AMENDMENT OF SOLICITATION/MODIFICATION OF CONTRACT			BPA NO.	1. CONTRACT ID CODE	PAGE 1 OF PAGES 31
2. AMENDMENT/MODIFICATION NUMBER 0003	3. EFFECTIVE DATE 01-29-2026	4. REQUISITION/PURCHASE REQ. NUMBER 586-26-1-1577-0005	5. PROJECT NUMBER (if applicable) 586-22-102		
6. ISSUED BY Department of Veterans Affairs Network Contracting Office 16 5075 Westheimer Road, Suite 750 Houston TX 77056-5643	CODE 36C256	7. ADMINISTERED BY (If other than Item 6) Department of Veterans Affairs Network Contracting Office 16 5075 Westheimer Road, Suite 750 Houston TX 77056-5643	CODE 36C256		
8. NAME AND ADDRESS OF CONTRACTOR (Number, street, county, State and ZIP Code) To all Offerors/Bidders			(X)	9A. AMENDMENT OF SOLICITATION NUMBER 36C25626R0012	
			(X)	9B. DATED (SEE ITEM 11) 12-12-2025	
			(X)	10A. MODIFICATION OF CONTRACT/ORDER NUMBER	
			(X)	10B. DATED (SEE ITEM 13)	
CODE	FACILITY CODE

AMENDMENT 0003

586-22-102 RENOVATE PC BLUE PACT WOMEN'S CLINIC RFI RESPONSES

1 NEW LIGHTING PLAN - MECH PENTHOUSE

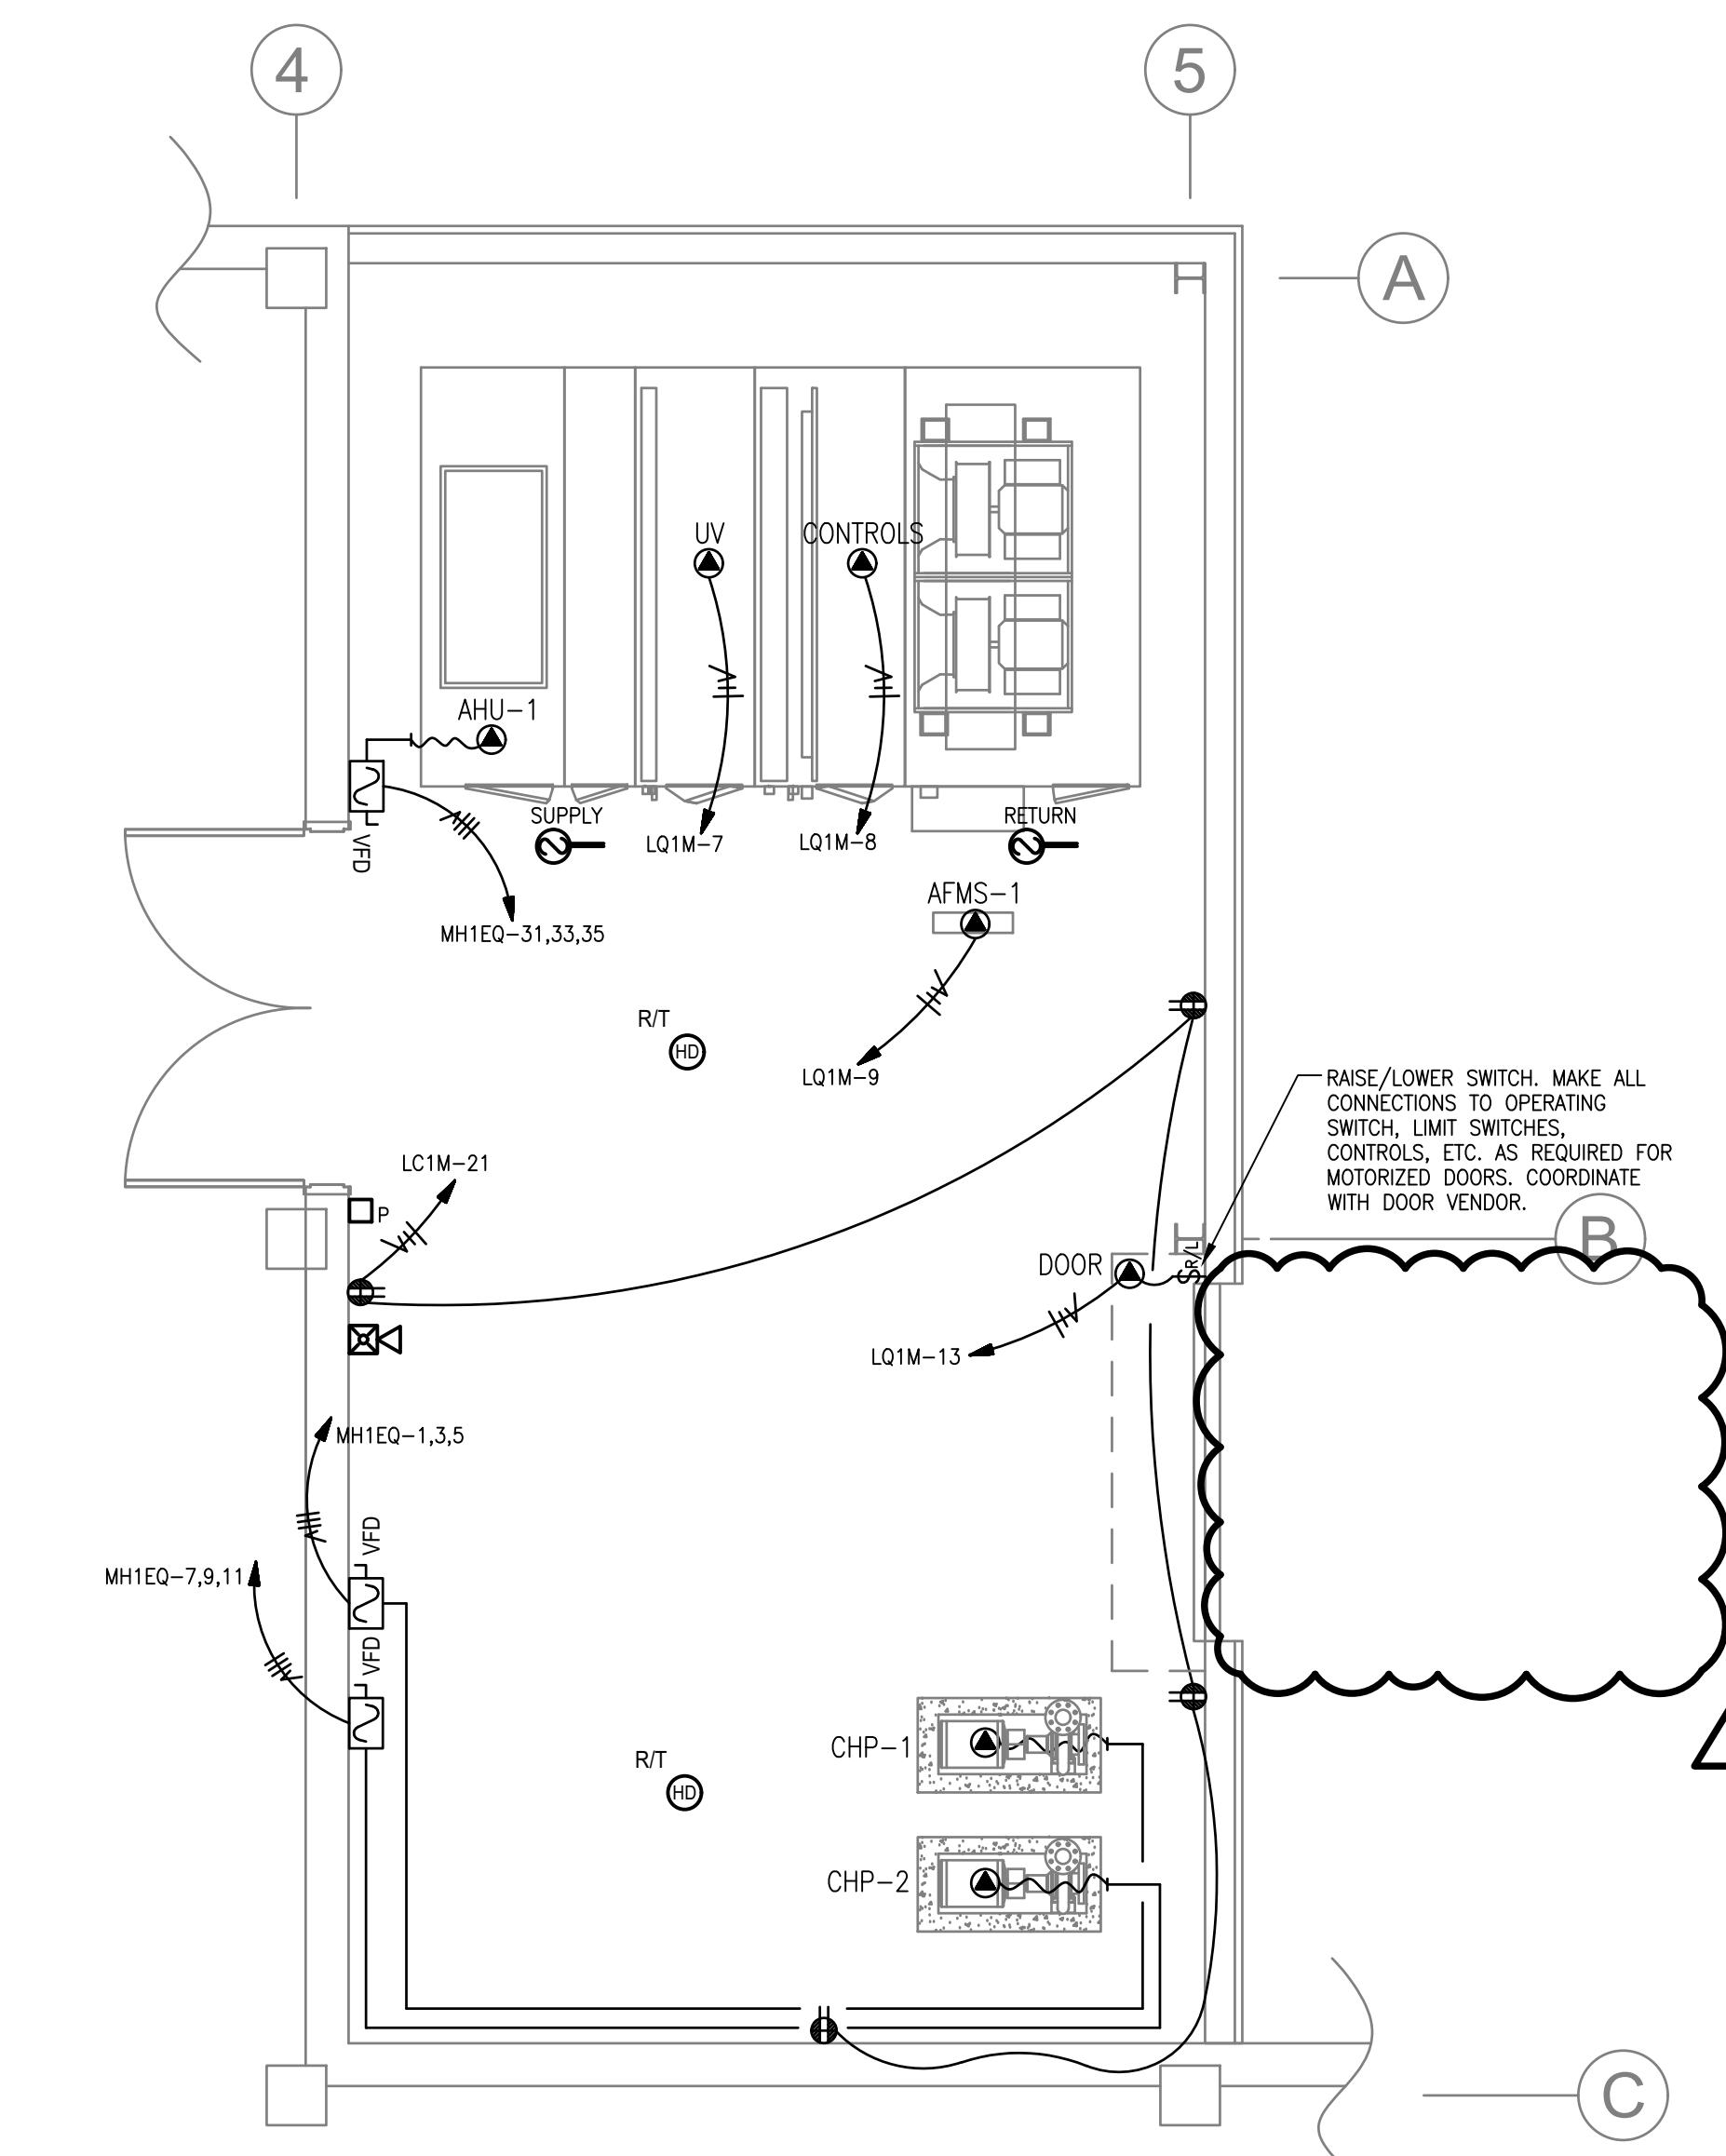
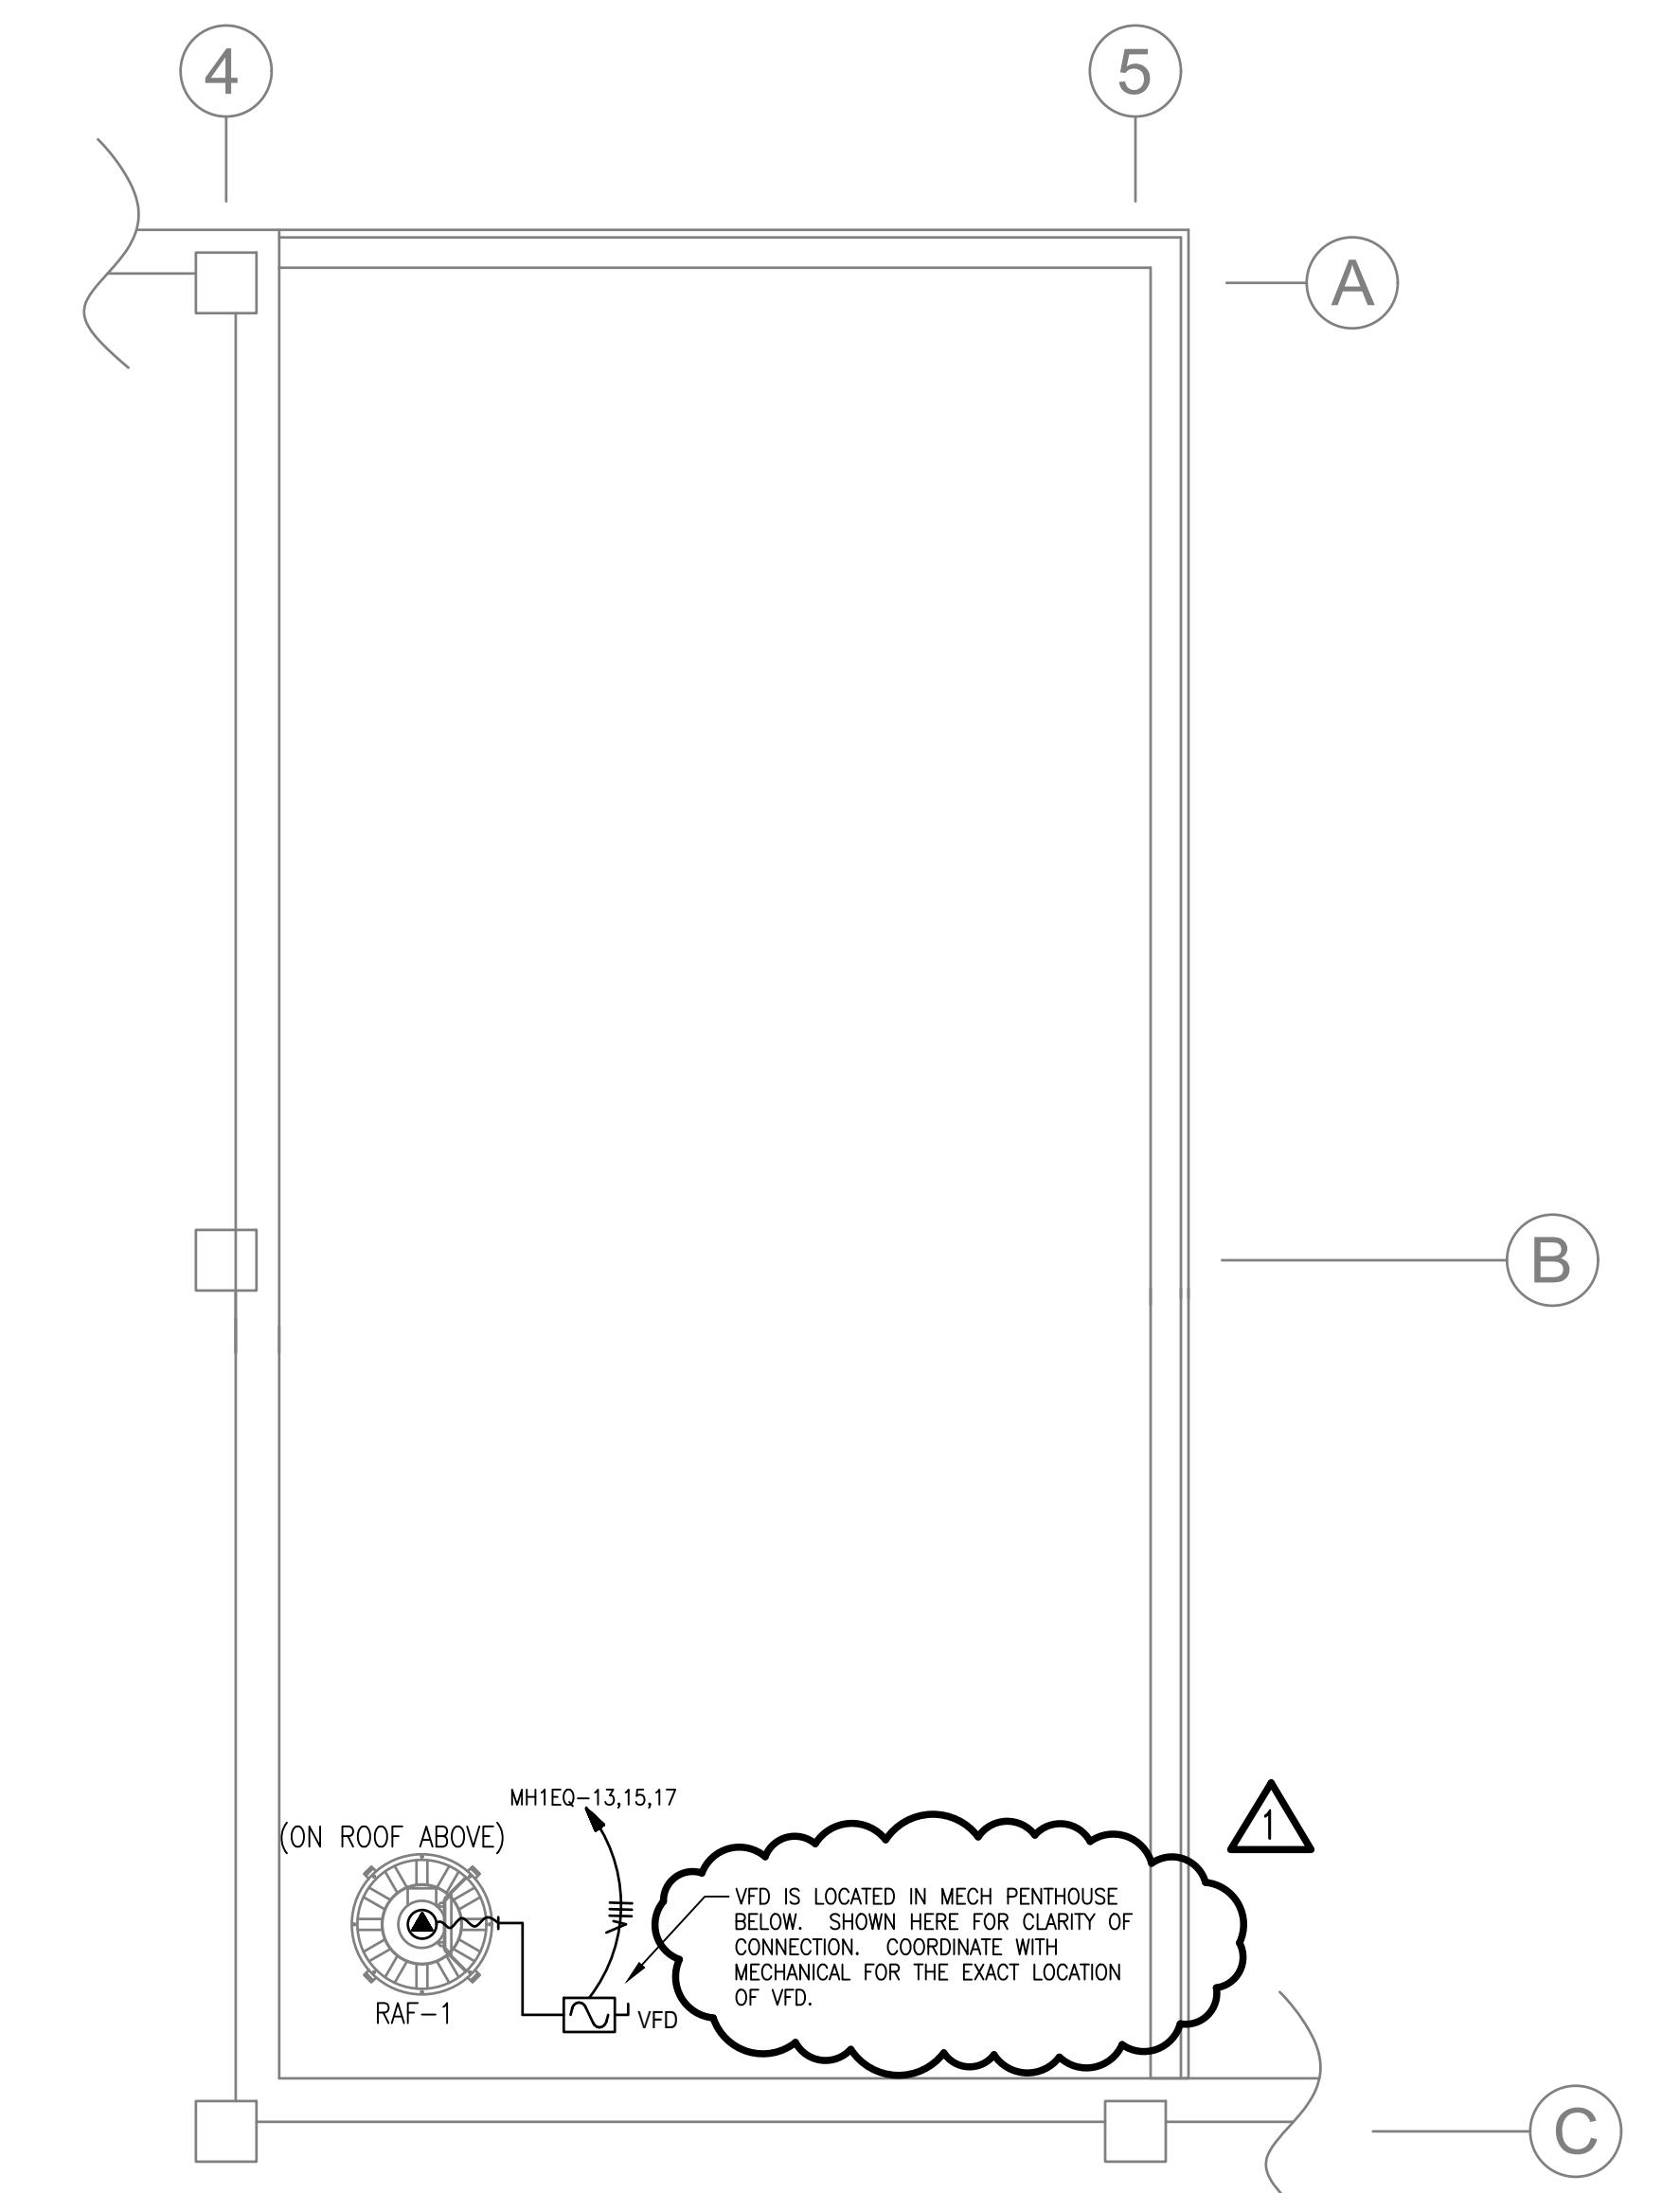
60. Electrical drawing page E205 shows a landing and stairwell on the exterior of the new penthouse outside the overhead door; however, the structural drawings do not show details for these items. Please provide clarification for this scope.

RESPONSE: The landing and stairwell shown on sheet E205 shall be deleted.
